TOYOTA CUSTOMER SERVICES

Volume: X
 Number: TC08-012
 Date: 07/24/2008
 Action
 Retain
 Information

SUBJECT: **Special Service Campaign (Recall) 80C – Phase 1**
 Certain 2004 - 2006 Model Year Sienna Vehicles Equipped w/Power Back Door (Power Rear Liftgate)

SPECIAL SERVICE CAMPAIGN (SAFETY RECALL) 80C

REAR LIFTGATE BRACKETS AND REAR LIFTGATE STRUTS

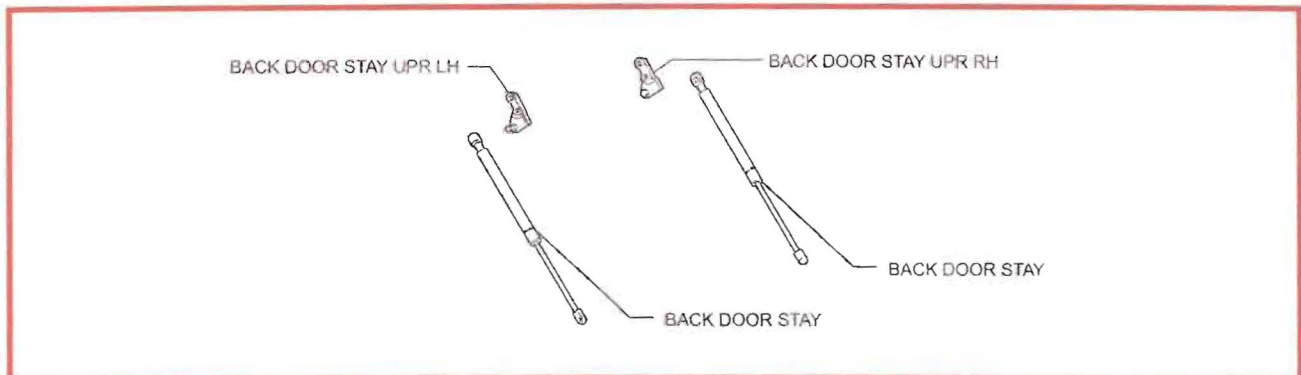
Toyota has determined that the gas struts used to help lift and support the Power Rear Liftgate in some Sienna vehicles are wearing out sooner than expected. As the gas struts deteriorate, the performance of the Power Rear Liftgate will begin to degrade, and the Power Rear Liftgate will operate more slowly than when the gas struts were new. If this condition is not repaired, the gas struts may not be able to support the weight of the liftgate when it is open. Eventually, the gas struts could deteriorate to the point that the liftgate will fall about ten inches after it reaches the fully open position, at which point the power motor will engage and power the liftgate to the fully closed position. This condition may cause injury to a person who is struck by the liftgate when it falls or when it is closing. Therefore, Toyota will conduct an SSC for the Power Rear Liftgate Struts.

Part Number	Part Description	Qty per Vehicle
04008-011AE	Back Door Stay (Rear Liftgate Struts) Kit, Power	1
The kit listed above includes the following parts:		
<ul style="list-style-type: none"> • 68905-AE013 = Stay Sub-Assy, Back Door = Qty 2 • 68955-08021 = Bracket, Back Door Stay, Upr RH = Qty 1 • 68956-08021 = Bracket, Back Door Stay, Upr LH = Qty 1

1. VERIFY THE SHAPE OF THE REAR LIFTGATE MOUNTING BRACKETS

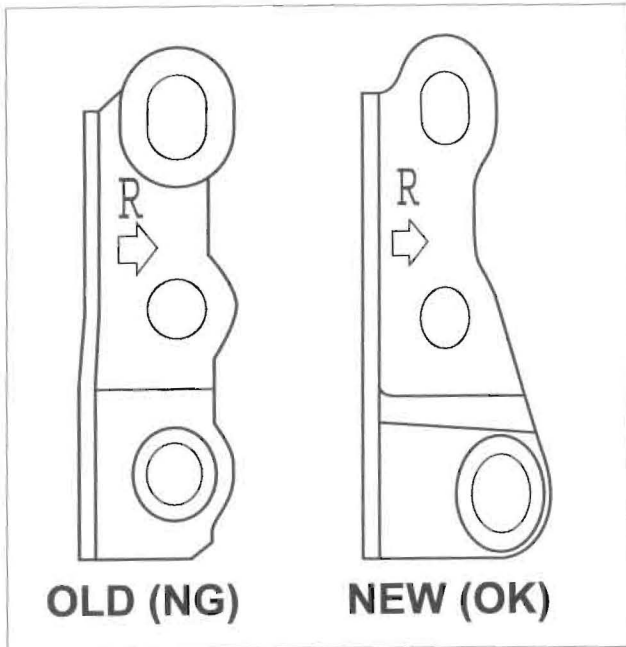
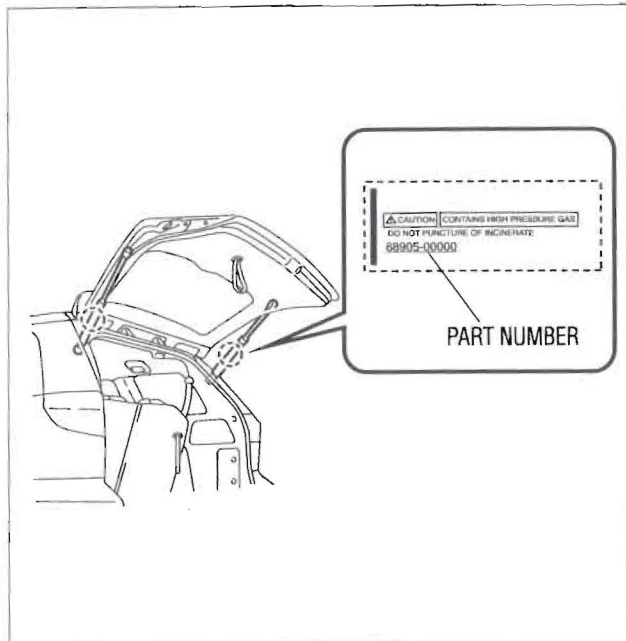
- Inspect the shape of both the Rear Liftgate Mounting Brackets (Vehicle side).
- If the new bracket type (wider shape) is found on both sides proceed to step 2.
- If the old bracket type (narrower shape) is found on either side, replace both struts and brackets using kit number 04008-011AE as outlined in TIS/Repair Manual.

NOTE: Failure to replace the old style brackets will cause premature wear to the new liftgate struts.
